VIRGINIA ELECTRIC AND POWER COMPANY
RICHMOND, VIRGINIA 23261

VIRGINIA ELECTRIC AND POWER COMPANY (DOMINION)
NORTH ANNA POWER STATION UNIT 1 - CMP-022R1
NORTH ANNA POWER STATION UNIT 2 - CMP-023R1
SUPPLEMENTAL INFORMATION TO SUPPORT
USE OF WELD OVERLAYS AS AN ALTERNATIVE REPAIR TECHNIQUE

ADDITIONAL INFORMATION
USE OF A BARRIER LAYER TO MITIGATE HOT CRACKING

SUPPLEMENTED
ALTERNATIVE REQUEST CMP-022R1/023R1
USE OF WELD OVERLAYS AS AN ALTERNATIVE REPAIR TECHNIQUE

Figure 1: High Sulfur Stainless Pipe exhibiting ERNiCr-3 Deposit between ENiCrFe-3, ER309L, and ERNiCrFe-7A deposits.

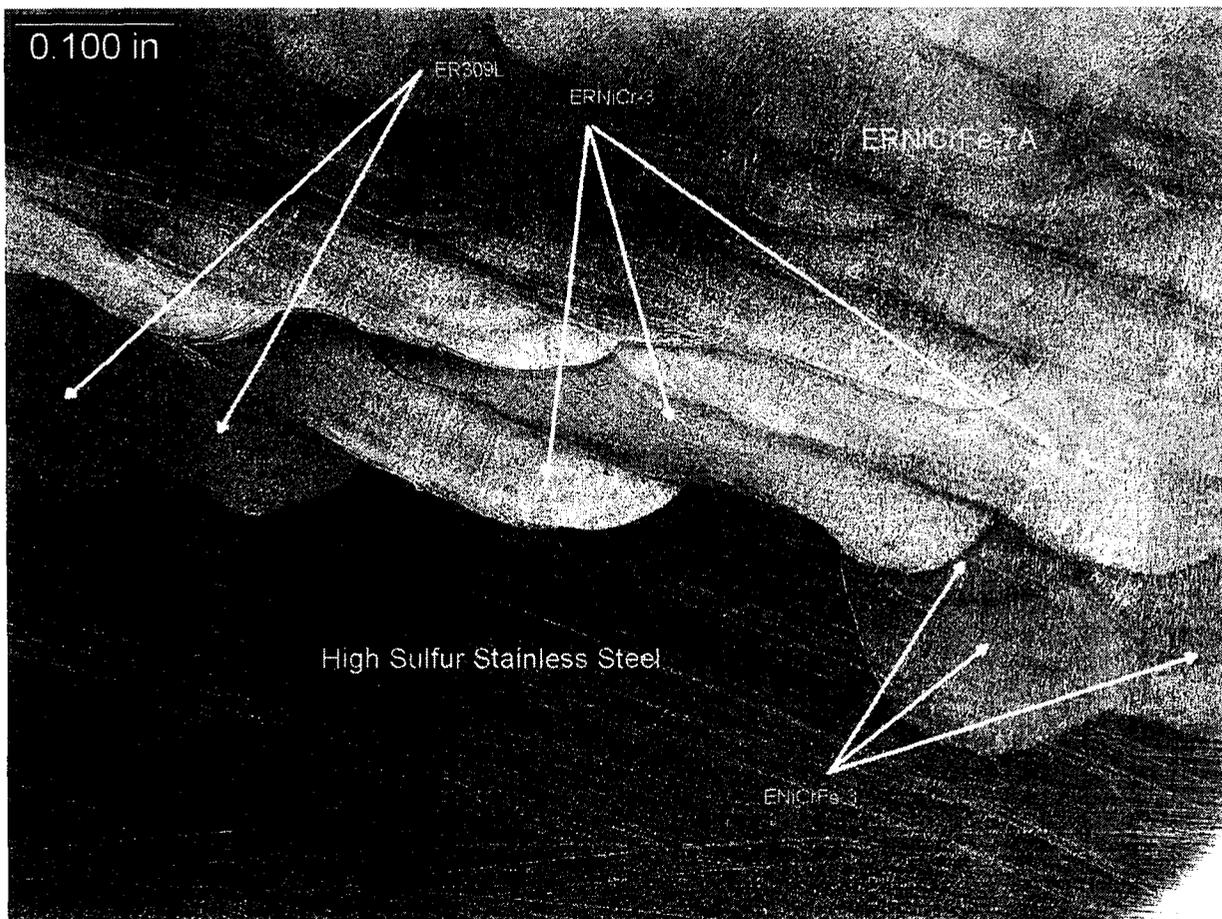
11. Could the mixture of 309SS, 182 and 52M filler material in the first layer cause any hot cracking or lack of fusion?

AREVA has performed a mockup of this very scenario with excellent results. The mockup consisted of high sulfur stainless pipe (0.020 sulfur content) with an ENiCrFe-3 (Inconel 182) structural weld with filler materials ER309L (309L), ERNiCr-3 (Inconel 82) and ERNiCrFe-7A (Inconel 52M). The mockup was performed in accordance with established Welding Procedure Qualifications and Welding Procedure Specifications.

The "82" mockup has passed the following examinations with No Recordable Indications:

Initial metallographic of the mockup was performed looking for any type of discontinuity, anomalies, or flaws (single specimen with "rough" polish and etch). See Figure 1.

The "82" mockup is undergoing additional metallographic testing for a total of 8 specimens taken equidistance around the pipe being examined for any and all discontinuities, anomalies, and or flaws.
